Access Compliance Report

Public Rights-of-Way

Intersection ID: 14757	Main Street: E_WORTHINGTON_AV	Cross Street: LENNOX_AV	Location: S
ADA ID: 386882F8B139	Ramp Type: BlendTrans2	Initial Pass/Fail: Pass	Overall Compliance: No
		Severity Score: 17.5

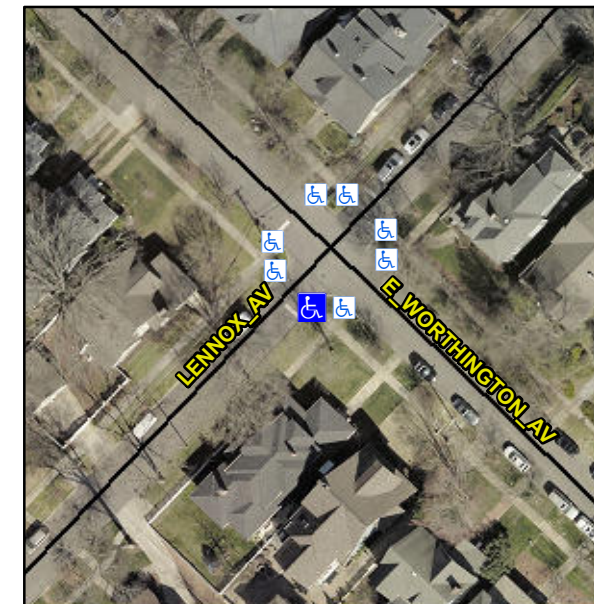
Not Found, R305.1.4, R302.7.2

N/A	Ramp inside XWalk1?	N/A	N/A	Ramp inside XWalk2?	N/A
	Road Slope (%)	1.3		Clear Space?	Yes
	Road X Slope (%)	1.6	N/A	Clear Space to XWalk (in)	N/A
Yes	Any Obstructions?	No	Yes	Storm Grate/Utility Hazard?	No
	Obstruction Type			Storm Grate/Utility Type	
		N/A			N/A
			Yes	Surface Condition? (G/P)	Good
			No	Curb Slope (%)	17.1

Remove & Replace Curb Ramp With Two New Directional Ramps or Equivalent.
